**RE: MOD2019/0029 – 46 Victoria Parade, Manly**

As requested in our meeting held on the 20<sup>th</sup> March 2019, this letter addresses the matters raised via submission letters received by Council in relation to the proposed design modifications in MOD 2019/0029 to the approved residential flat building at 46 Victoria Parade, Manly.

Extract of Level 4 Floorplan demonstrating setback and established view corridor line.

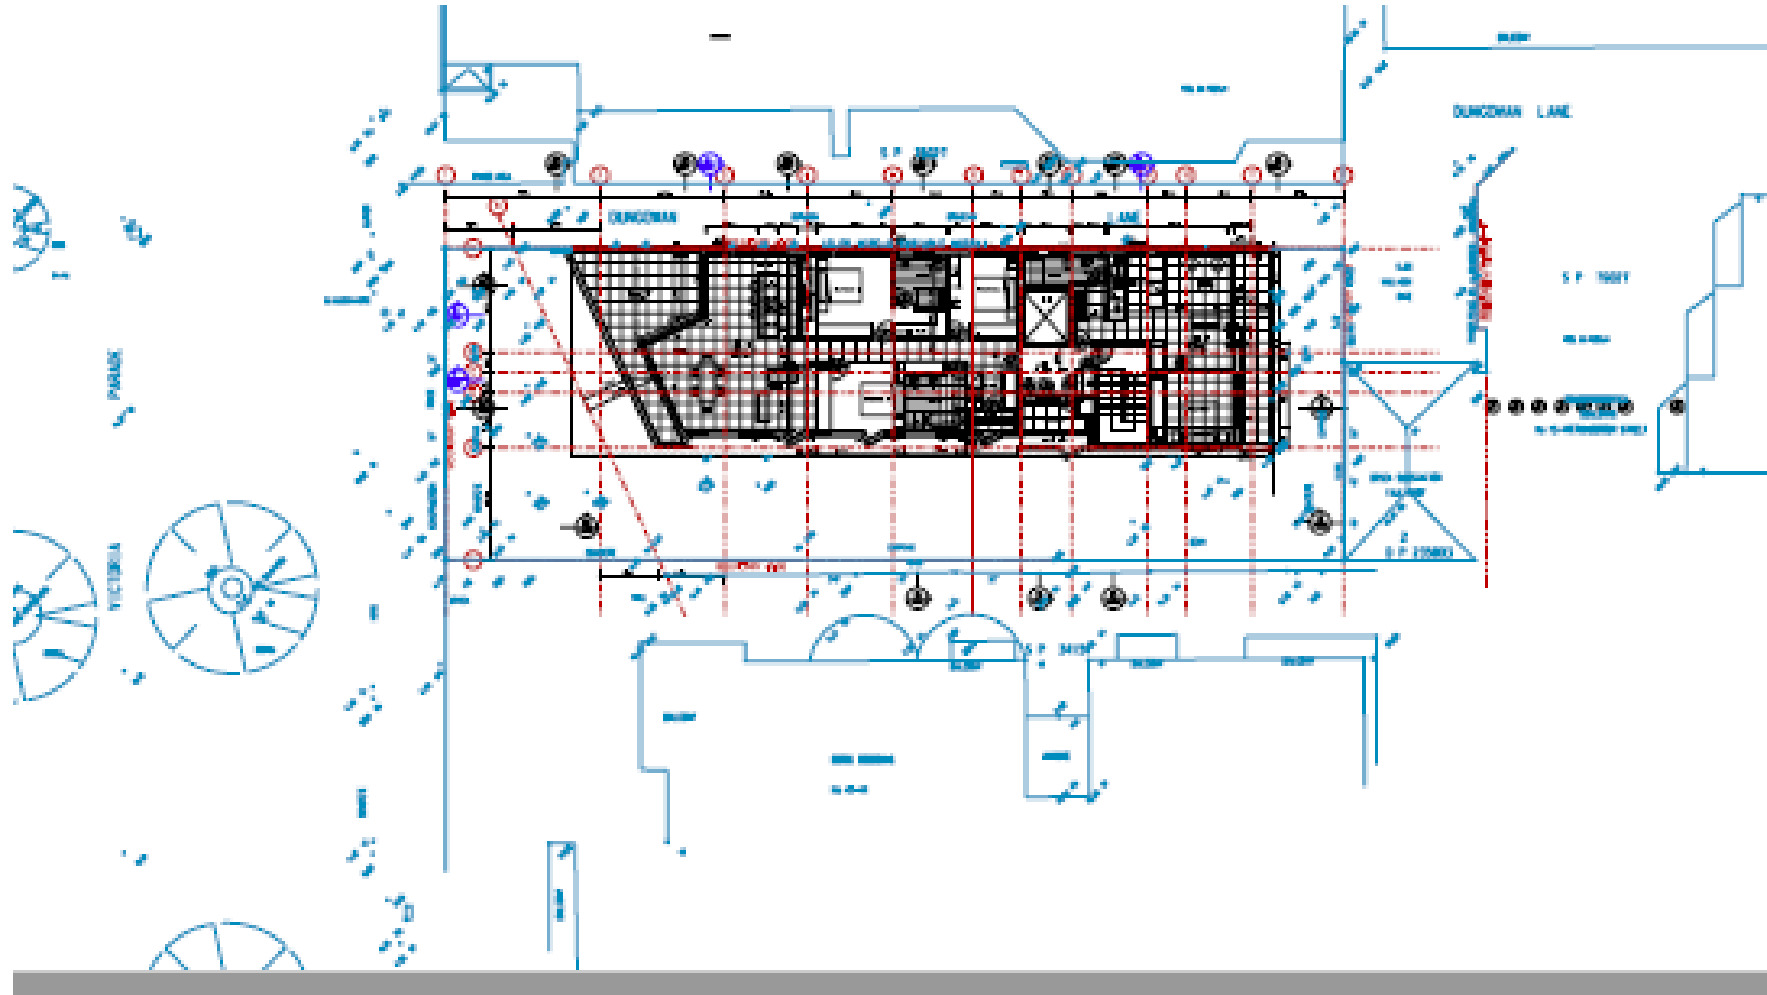
Furthermore, ARC Architects has reviewed the photographs as taken by Council from the top floor north easterly apartment in 42-44 Victoria Parade. The proposed building is not visible in any of

the photos provided, given that the building is significantly set back beyond the DA approved sightline. The sightline is clearly shown on the survey plan attached to the view analysis as provided with the application. The Level 4 floorplan attached to this response letter demonstrates the view line setback 2.1m at balcony and 3.35m to glass line.

**Extract of Level 4 View Analysis as submitted with the application. The view is taken from the north eastern corner of the building.**

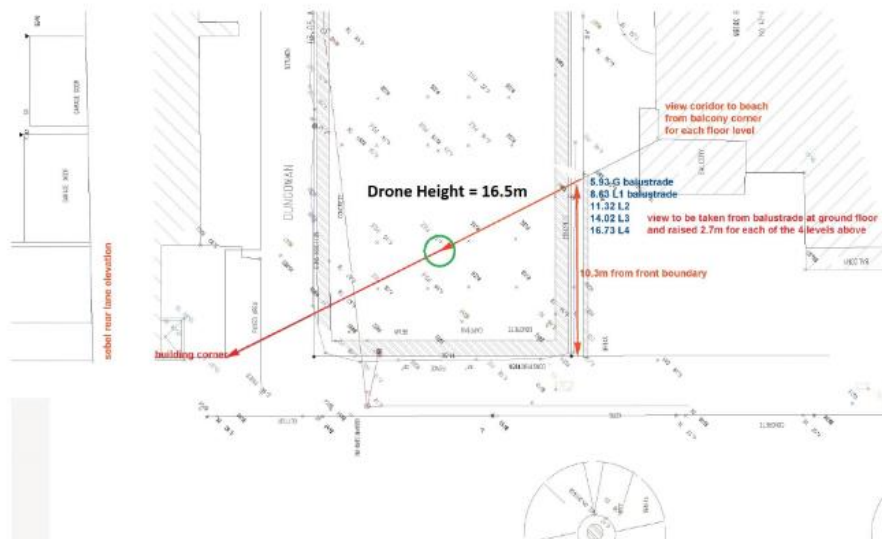
A number of the submissions raise concern with respect to view impacts. A detailed view analysis prepared by ARC Architects has been provided as part of the application documentation. Each of the wire frame views as provided in the view analysis is taken from the north easterly corner of the building (not the edge of the balconies), pursuant to the view corridor line as established in the Land and Environment Court proceedings. The RL heights are provided to each apartment. This view analysis details the modified floor to ceiling heights to the proposed building in comparison to the established view lines from each of the apartments at 42-44 Victoria Parade.

The view analysis clearly demonstrates that the established view lines of Manly Beach across the subject site as obtained from the relevant apartments at each of the levels within 42-44 Victoria Parade are retained and protected as a result of the proposed design modifications.
